SEWAGE DISPOSAL SYSTEM

HOWARD COUNTY
BUREAU OF ENVIRONMENTAL HEALTH
461-9933

SUBDIVISION Glenelg Manor II ROAD 12873 Folly Quarter Rd LOT 27A

PERCOLATION TEST PLAT
 PARCEL 27A
 GLENELG MANOR II

GRADING STUDY	OR SPECIAL ARRANGEMENTS MADE TO
LOT 27 A "GLENELG MANOR II"	CHECK SEPTIC SYSTEM AT
5th ELECTION DISTRICT HOWARD COUNTY, MARYLAND	TIME OF BUILDING INSPECTION
SCALE: 1"=50'	DATE: 3/21/90

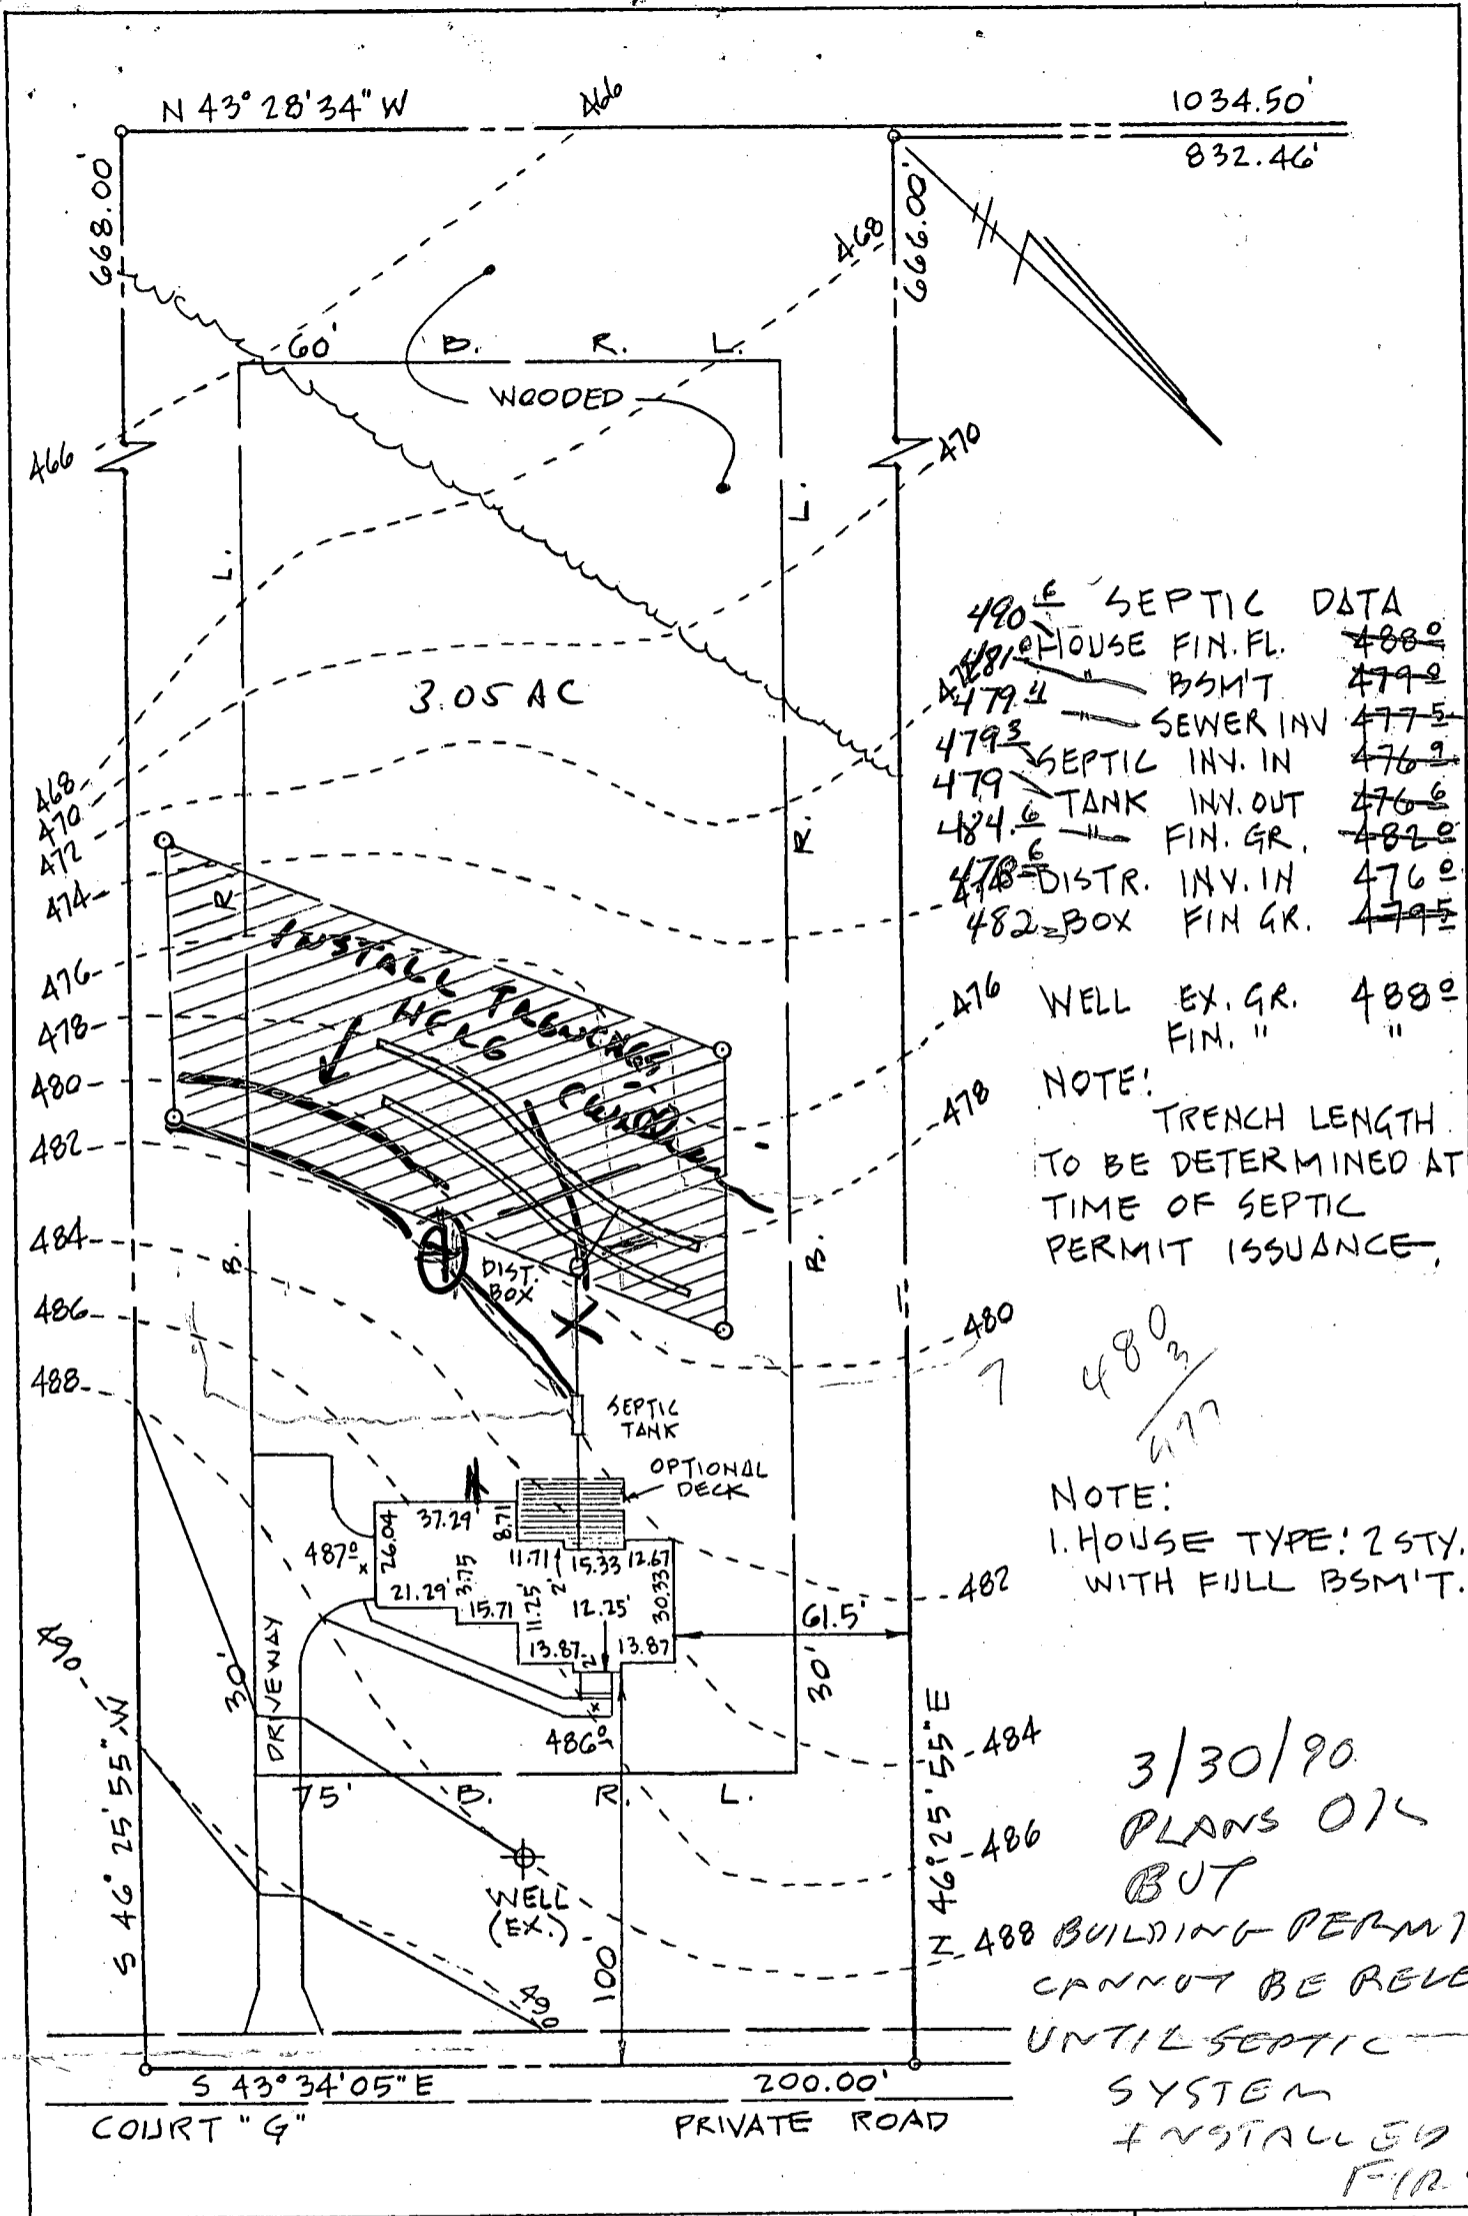
3/30/90
PLANS OK BUT
Z 488 BUILDING PERMIT CANNOT BE RELEASED UNTIL SEPTIC SYSTEM INSTALLED FIRST

ELEVATIONS RAISED - OK TO RELEASE OP. CHECKED 3/14

SITE PLAN
 SCALE: 1"=50'

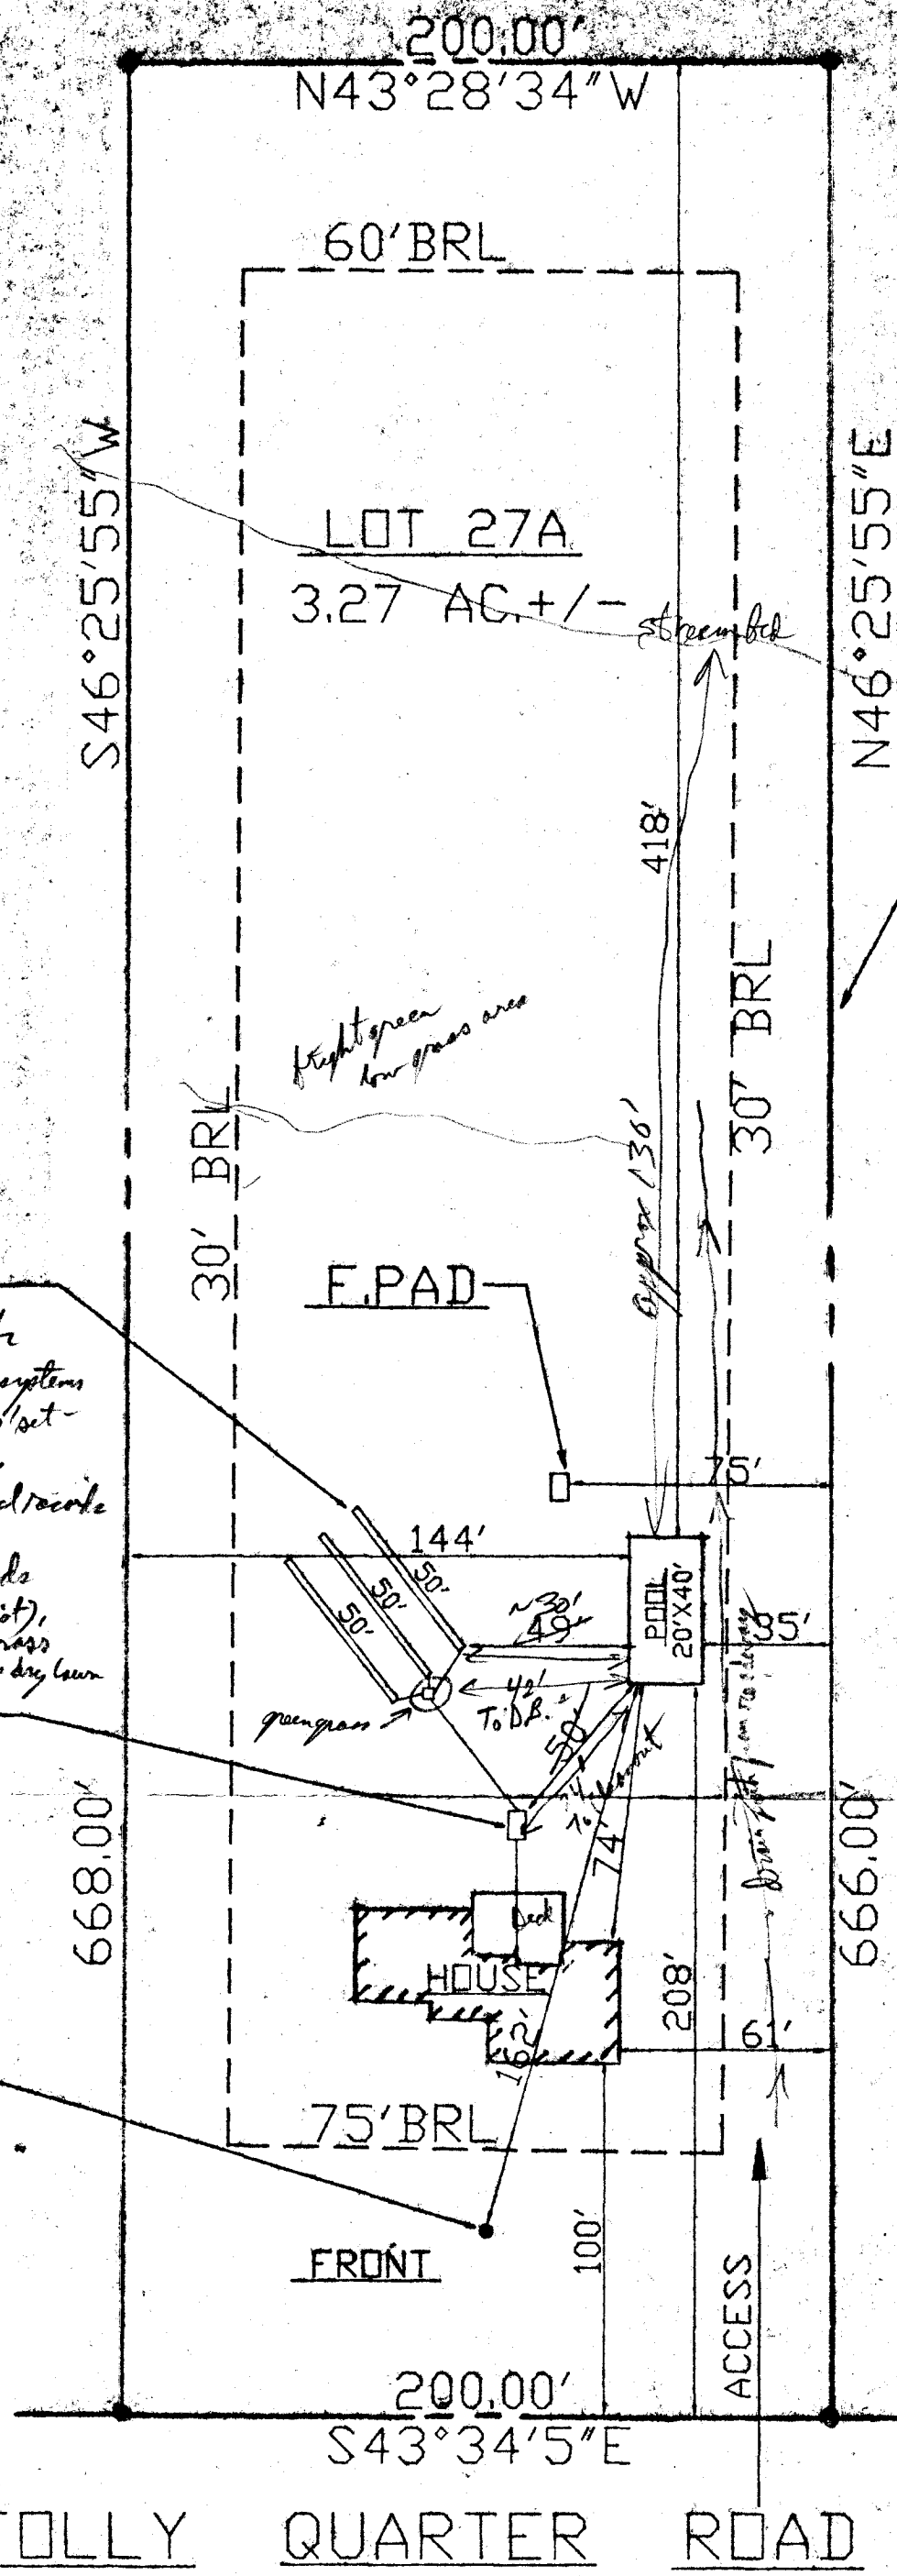
TYP. 3 EXIST. DRAIN FIELDS
estimate enough for one (maybe 2) repair systems fibre hit low area (100' set-back from stream bed, - Need to look up original records off well top & - Prof drain pathway leads directly to S.T. (soil v. moist). This could explain green grass around S.T. & D.B. in other areas dry lawn

Records how plotted SDA runs into proposed pool site water table in early Feb '85 at 11 ft or lower test holes. I recommend No Approval at this time. See letter of 9/13/94

SITE PLAN

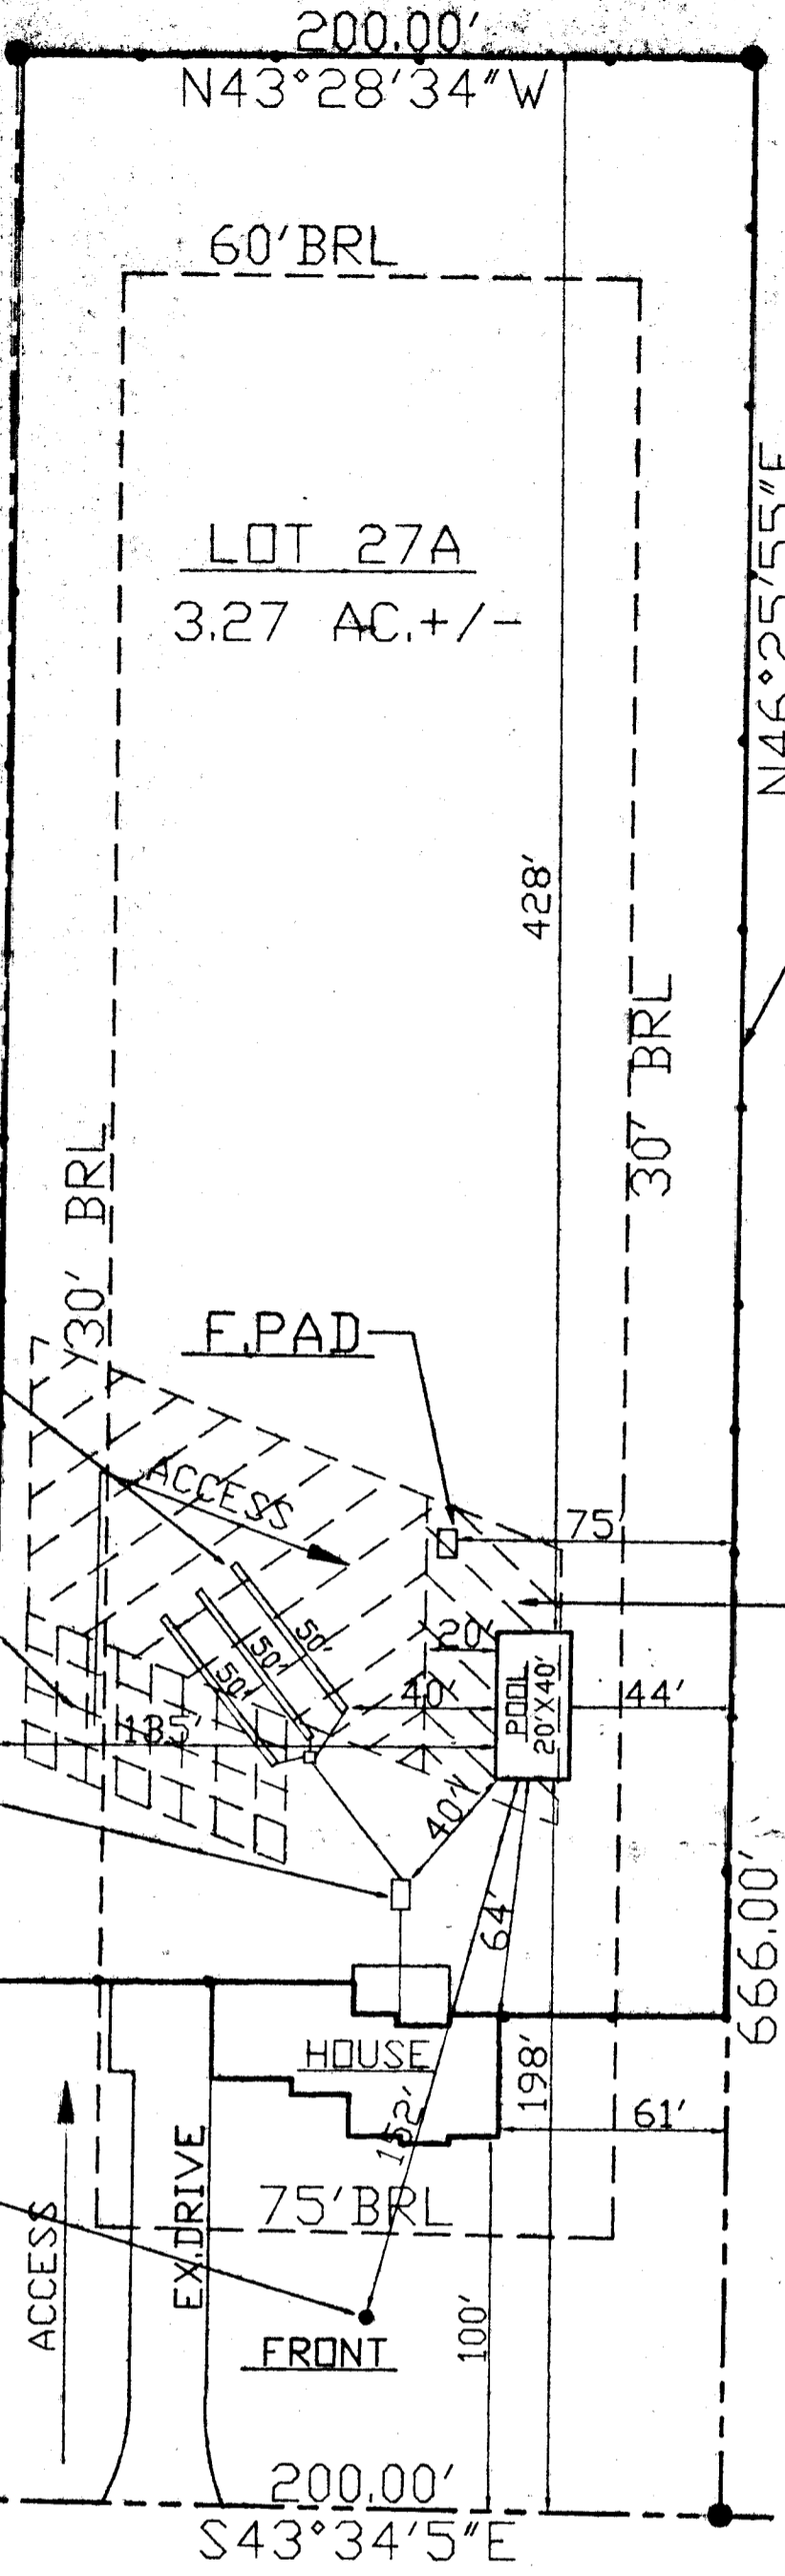
2590 SQ. FT. RELOCATED SEPTIC RESERVE AREA

See Galloway 7/13/94
